CCO #18-012

Project: 0483-01 - Perris High School No. 4
32255 Leon Road
Winchester, California 92596

Change Order #18-012: Cat. 18 - PCOs 10 & 25

SHEET REF:	AD-2.1.1
DOC. REF:	CCD-093
CONTR. REF:	
DATE:	01.28.2020
JOB NO:	14001-00
DRAWING:	X-453

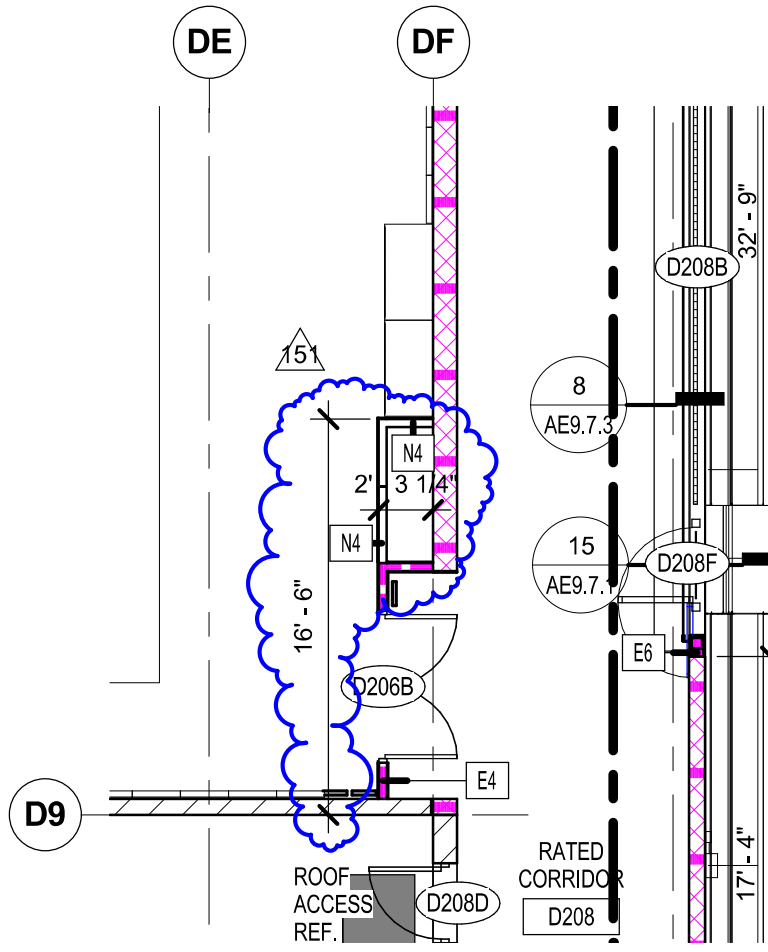
At Bldg D, there are no vents or intakes shown for the water heaters in room D118. These water heaters require both a vent and intake with limited footage and fittings. The plumber provided a possible solution, see attached. Please advise.

INFORMATION REQUESTED: There are no vent or intake shown on Plumb drawing, these water heaters require a vent and intake with limited footage + fittings

SUGGESTED COURSE OF ACTION: I have picked a location to route this piping up through 2nd Floor + roof it is approx 17 to 23' east of D-5 line on face of block on DF line, would need a chase wall to conceal piping in wrestling room D206. see attached drawing

Revised water heater vents per CCD 93
Costs include credit for vents per Detail 4/P5.2

Official Response: Leo Contreras (**BakerNowicki Design Studio**) responded on Wednesday, February 5th, 2020 at 5:56PM PST
Per CCD 093.

Official Response: Vince Vegas (**MA Engineers, Inc.**) responded on Tuesday, February 4th, 2020 at 10:36AM PST
Refer to CCD034 for CA+V through roof. Refer to CCD093 for shaft/horizontal routing.

CCD 163	Roof Drain Pipe Lengths
19	34
20	10
21	10
22	26
23	26
24	8
25	30
26	30
27	10
28	10
29	36
30	36
31	8
32	8
Total	324

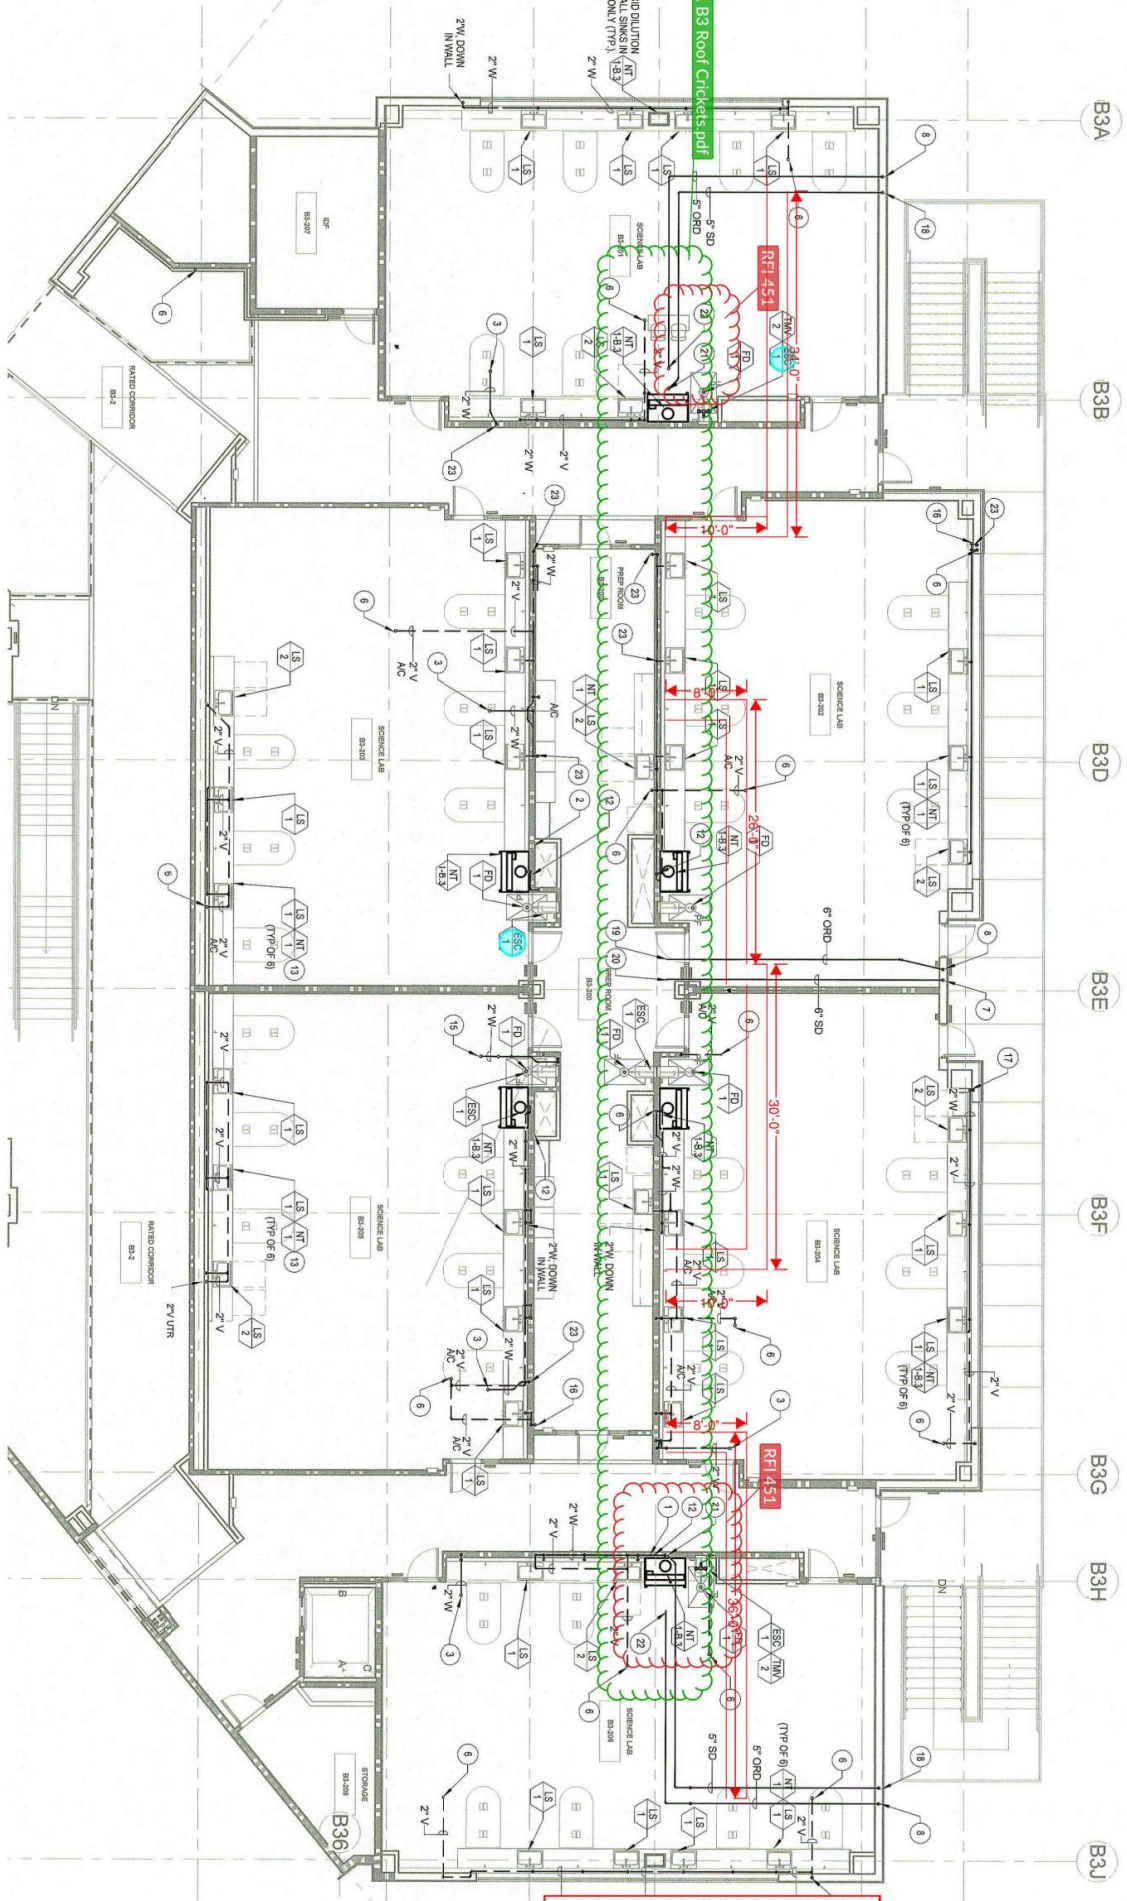
1. Please have the plumbing contractor verify LF of 4" pipe. They list 300 LF and I can only confirm 172 LF, see takeoff below.

B3 interior work continued thru November & December 2020 (to the extent possible without a roof in place) while this B3 roofing issue was being resolved. When roof drains arrived in January congestion from work in place and the requirement to slope drains apparently precluded Fischer from routing drain lines as shown on CCD 163 P sheets. Fischer's as-built plans for the added roof drains is included in support of the quantity of pipe charged in this PCO. Neff has verified Fischer's take-off and believes the quantity to be correct based on their as-built routing.
